RECORD OF DECISION

**BUCKINGHAM COUNTY LANDFILL SUPERFUND SITE
BUCKINGHAM COUNTY, VIRGINIA**

**PREPARED BY
THE U.S. ENVIRONMENTAL PROTECTION AGENCY**

SEPTEMBER 1994

FIGURE 3

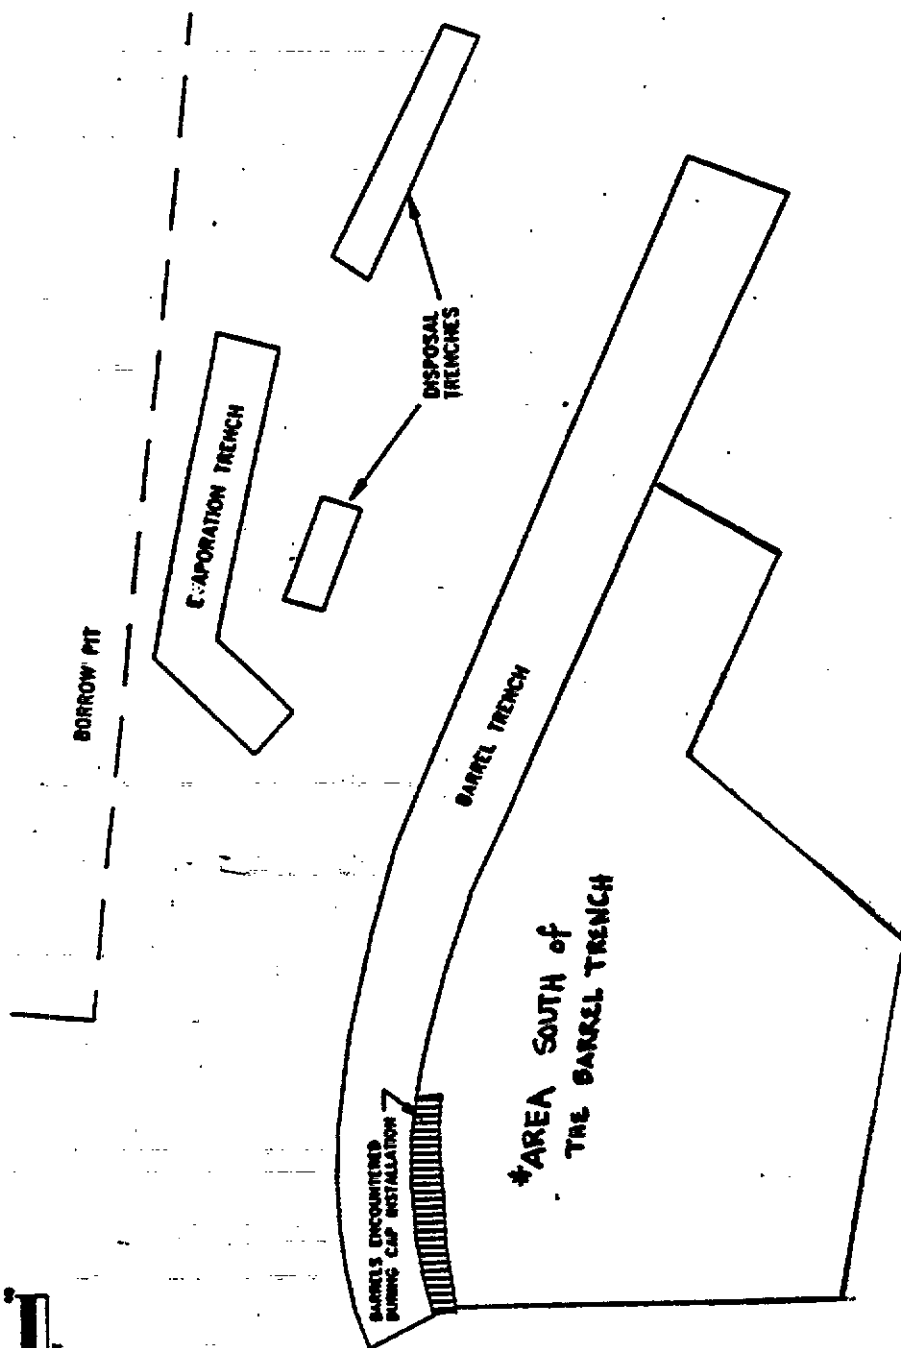
7. The area of the barrel trench has been questioned. It has been stated by the PRPs that the entire barrel trench was not represented in the proposed remedy.

EPA Response: During operations at the Site, the barrel trench was located at the southern portion of the Site and, as described on page 1-8 of the RI, was approximately 400 feet long, 20 feet wide, and 14 feet deep. This area was specifically used for disposal of supposedly empty, crushed drums. This trench was never completely filled; The west end remained open until the Site was closed in 1983. During installation of the cap in 1983, portions of empty crushed drums were found mixed in with the solid waste landfill south of the barrel trench. Fourteen test pits were dug in this area to determine if drums were disposed of throughout this area. Five test pits uncovered portions of empty drums and two pits uncovered cloth laden with solvents. There were no reports of finding drums containing hazardous wastes. EPA does not consider the area where the test pits were dug to be
